9221 MOUNT HOLLY RD

SOIL/SITE EVALUATION
for ON-SITE WASTEWATER SYSTEM

Re: 9221 Mount Holly Road
File: 1140A
Parcel: 055-072-06

Receipt of your Application for Improvement Permit for the above referenced property is acknowledged. A soil evaluation and a site visit have been conducted. The results of the evaluation indicated that the site is **UNSUITABLE** under Rules .1941 **SOIL CHARACTERISTICS (MORPHOLOGY)**, .1943 **SOIL DEPTH** and .1945 **AVAILABLE SPACE**. For these reasons your Application for Improvement Permit is denied. A possible way to develop the site exists under Rule .1948(d) which reads as follows:

SOIL/SITE EVALUATION *for* ON-SITE WASTEWATER SYSTEM

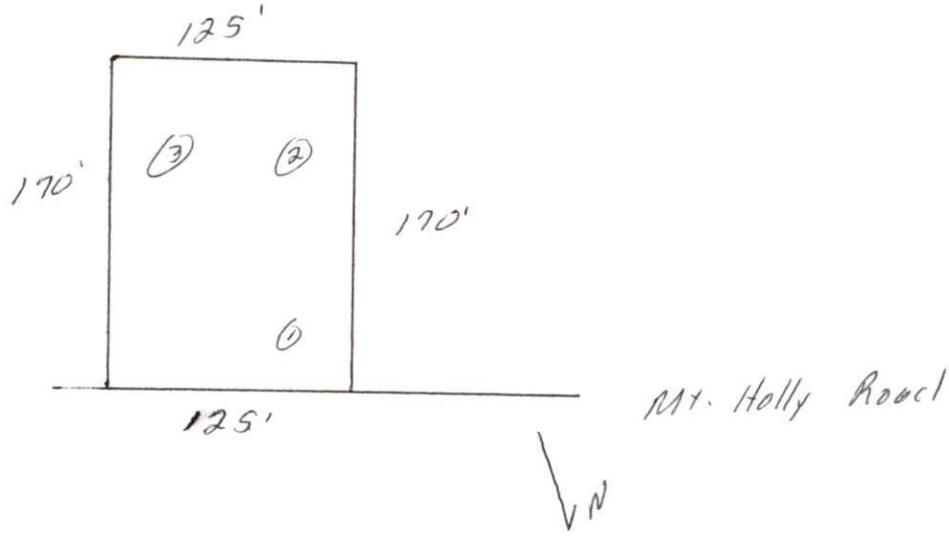
OTHER FACTORS (.1946):
SITE CLASSIFICATION (.1948): unsuitable
EVALUATED BY: William R. Marlin 8-10-96
OTHER(S) PRESENT: LSS

COMMENTS Saprolite investigation

SOIL/SITE EVALUATION
for ON-SITE WASTEWATER SYSTEM

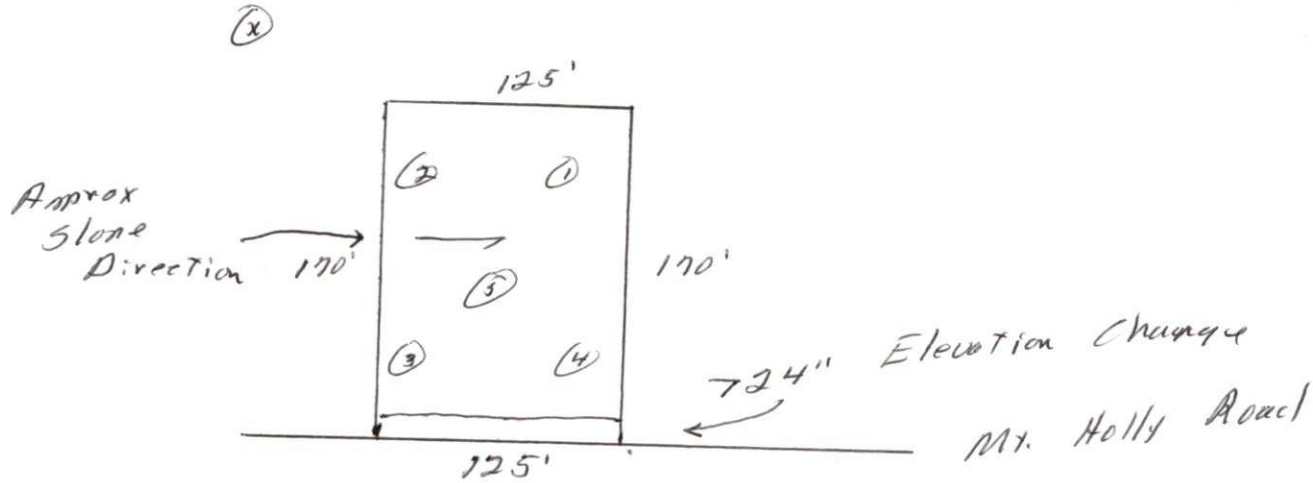
OTHER FACTORS (.1946): _____
SITE CLASSIFICATION (.1948): Unsuitable
EVALUATED BY: W. R. Marlin 6576
OTHER(S) PRESENT: LSS

COMMENTS Does not appear to be HOZ repair
